Association of Oregon Rail and Transit Advocates

MEMORANDUM

To: Members of the Fourth Alternative Subcommittee, Columbia River Crossing Task Force
From: Jim Howell, Director and Strategic Planner
Re: Recommendation for a Fourth Alternative

**Critique of the CRC Staff Assessment of AORTA's Proposed Nov. 8, 2006 Concept for
A Columbia River Crossing Emphasizing Public Transportation (keyed to Map)**

Assesment of AORTA's
Proposed 11/08/2006 Concept

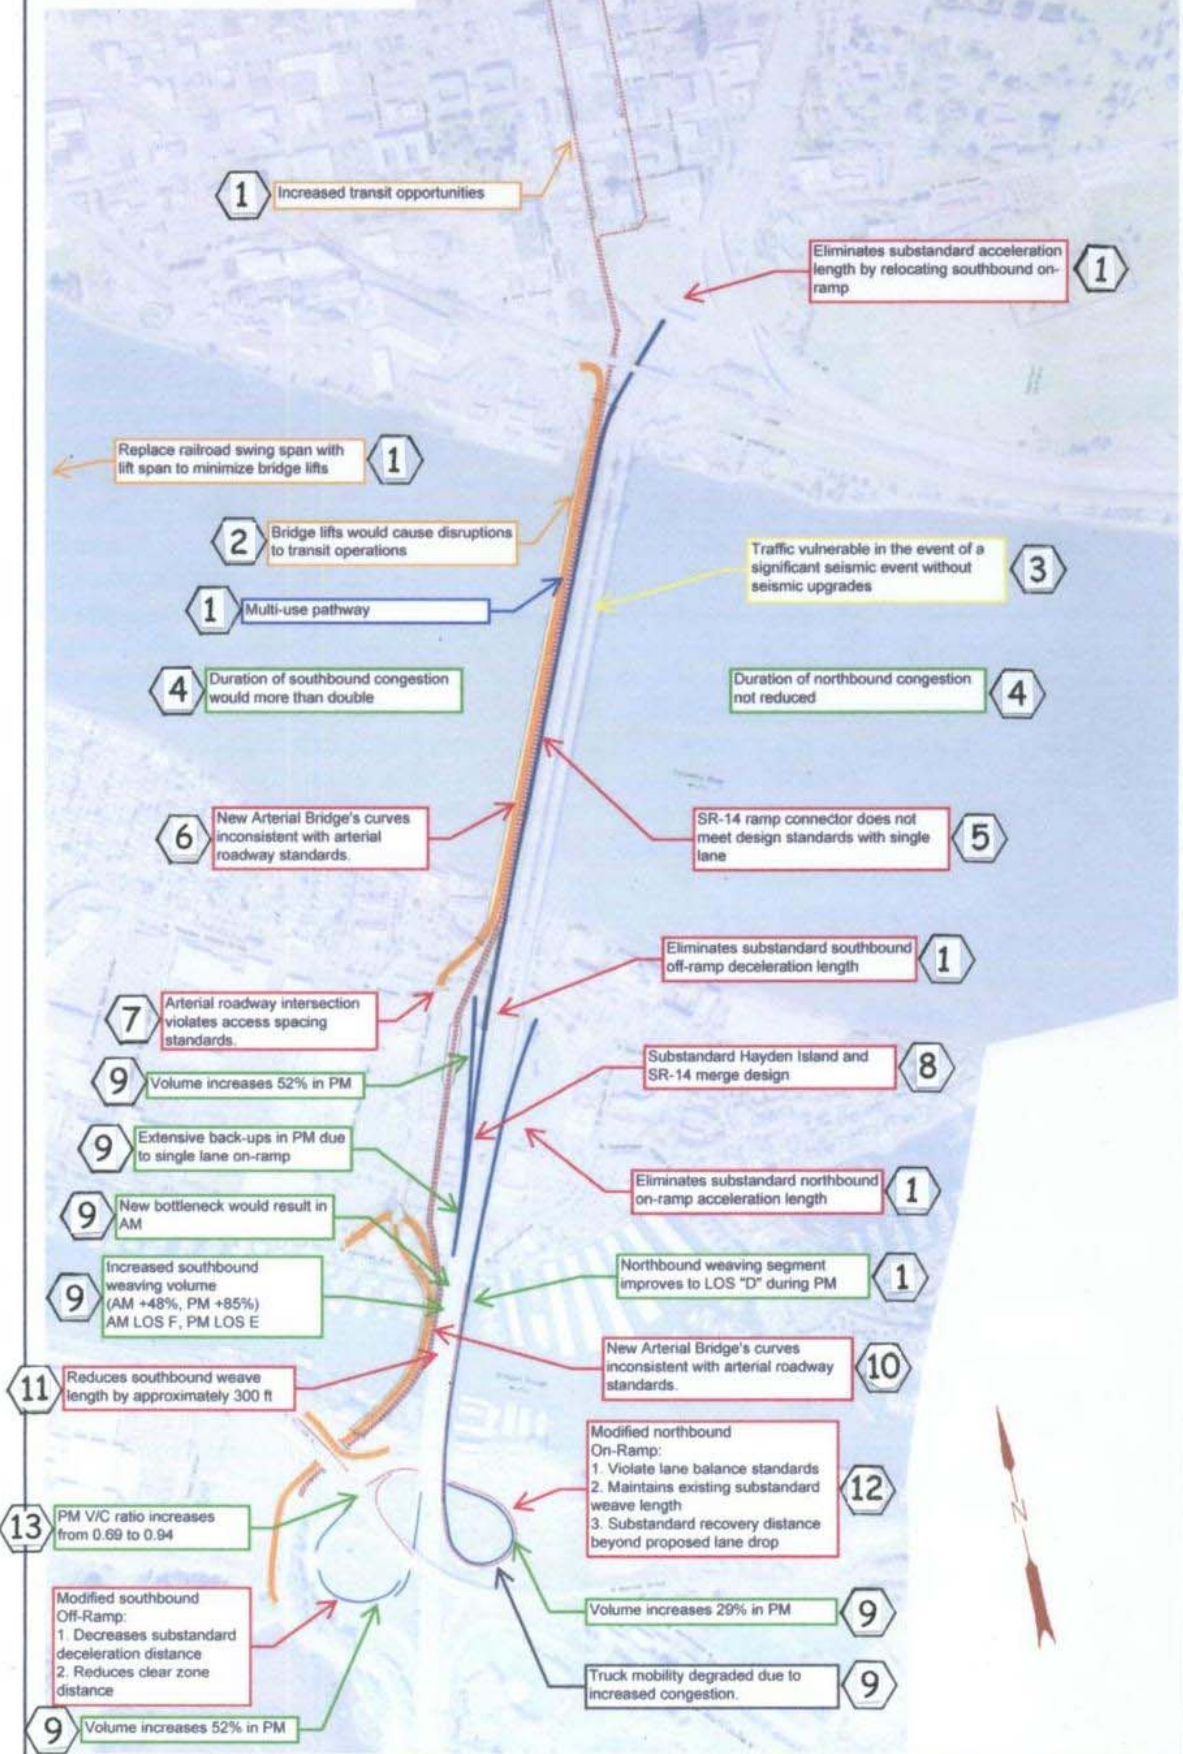
2 Bridge lifts would cause disruptions to transit operations

3 Traffic vulnerable in the event of a significant seismic event without seismic upgrades

4 Duration of southbound congestion would more than double

4 Duration of northbound congestion not reduced

6 New Arterial Bridge's curves inconsistent with arterial roadway standards.

5 SR-14 ramp connector does not meet design standards with single lane

7 Arterial roadway intersection violates access spacing standards.

8 Substandard Hayden Island and SR-14 merge design

9 Volume increases 52% in PM

9 Extensive back-ups in PM due to single lane on-ramp

9 New bottleneck would result in AM

9 Increased southbound weaving volume (AM +48%, PM +85%) AM LOS F, PM LOS E

10 New Arterial Bridge's curves inconsistent with arterial roadway standards.

12 Modified northbound On-Ramp:
1. Violate lane balance standards
2. Maintains existing substandard weave length
3. Substandard recovery distance beyond proposed lane drop

13 PM V/C ratio increases from 0.69 to 0.94

9 Volume increases 29% in PM

1. Correct
2. Incorrect - With the relocation of the railroad bridge's opening span, a lift span on a new multi-modal bridge would not have to be opened during transit operating hours due to infrequent movement of high vessels.

3. A significant seismic event would most likely make I-5 vulnerable throughout the metro region. To my knowledge, the relative vulnerability of all the structures on I-5 in the metro area has never been documented. Requiring the Columbia River structures alone to be seismically upgraded without this evidence is capricious since AORTA's Concept requires no other modification to the existing bridges. The purpose of improving the interstate river crossing's structural integrity would be accomplished by constructing the multi-modal bridge to modern seismic standards, providing a robust crossing for priority traffic during a major seismic event.

4. Incorrect - Light rail will more than double the river crossing capacity and aggressive expansion of effective bus service feeding light rail on both sides of the river will reduce peak hour demand and duration of freeway congestion.

5. Map is a concept, not an engineering drawing; SR-14 ramp connector on the multi-modal bridge can be two lanes up to a ramp meter on Hayden Island.
6. Map is a concept, not an engineering drawing; the local vehicle connection is not intended to be an arterial, but rather a two lane street connector between Hayden Island and Columbia Street controlled with a traffic signal at each end.

7. Map is a concept, not an engineering drawing; access spacing can be easily modified.
8. Map is a concept, not an engineering drawing; a safe merge can be designed in the 2,600 feet distance between the south end of the existing bridge and the Marine Drive off-ramp.

9. Incorrect - Traffic volumes and projected backups and bottlenecks are based on the erroneous assumption that all traffic to and from Hayden Island will continue to use the freeway exclusively in spite of light rail and enhanced feeder bus service in Vancouver, Portland and Hayden Island. This plus independent local street, bike and pedestrian access to and from Portland and Vancouver.

10. Map is a concept, not an engineering drawing; the vehicle connection across the Portland Harbor is not intended to become an arterial but rather a two lane local street connection between N. Center Avenue on Hayden Island and N. Expo Road. A 25-MPH speed limit is desirable.

11. Map is a concept, not an engineering drawing; safe weaves and merges (see #8 above), in any segment, are determined by traffic volumes. Traffic on the Hayden Island and SR-14 on-ramps can both be metered to allow safe merges and weaves.

12. The existing Portland Harbor Bridge gains a NB lane by moving bikes and pedestrians to the new bridge allowing trucks an un-metered access lane. See #8 and #11 above re: weaves and details.

13. Aggressive transit development will reduce demand and intersection's vehicle capacity can be increased with design modifications.
